Source: Leece-Neville Heavy Duty Systems Division
Bulletin No: TSB-1213 **Date:** August 19, 2022
Models: 4800 ign. excite with remote sense
Subject: Terminal Id. from 4800 to HAB alternators

Various 4800 series ignition excite brush alternators can be replaced by BLD4000 series brushless alternators. See matrix below.

This document will help identify terminal location variances.

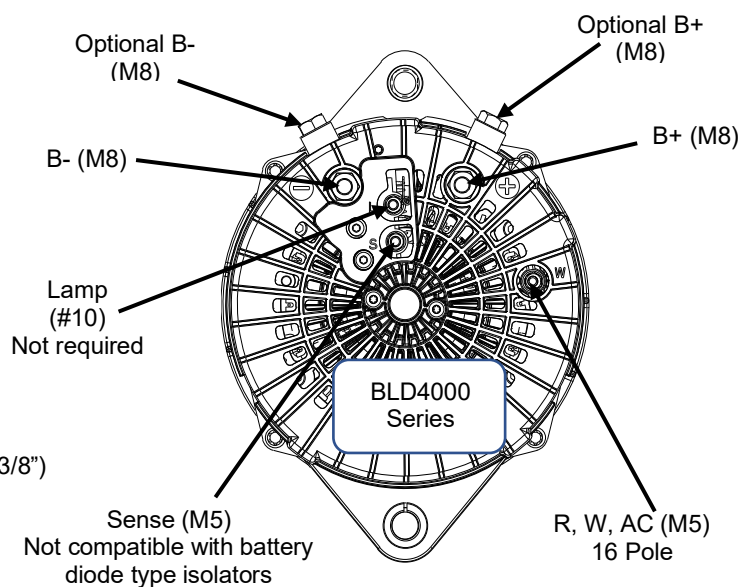
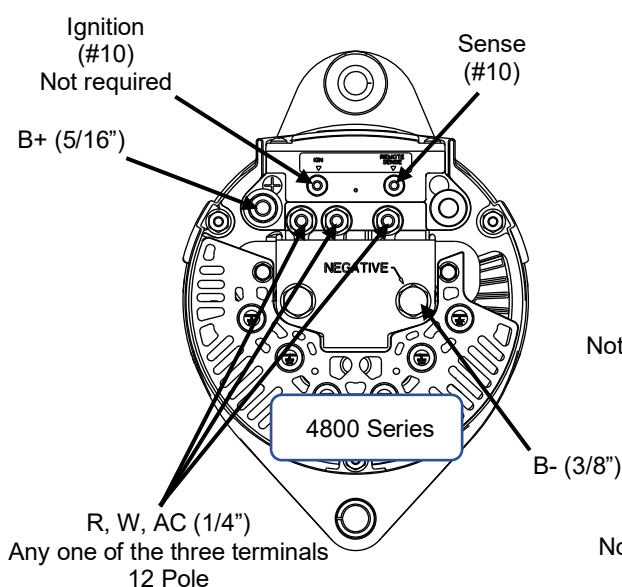
Note: Wire termination and routing will require changes.

Ignition lead used on existing 4800 series alternators are not required. Insulate this wire to prevent shorting and secure out of the way.

Remote sense used on BLD4000 series alternators are not compatible with traditional diode type battery isolators. Verify application.

4800 series alternators listed on this document are grounded earth return where the BLD4000 series replacements are insulated return. Depending on the vehicle wiring a ground strap maybe required.
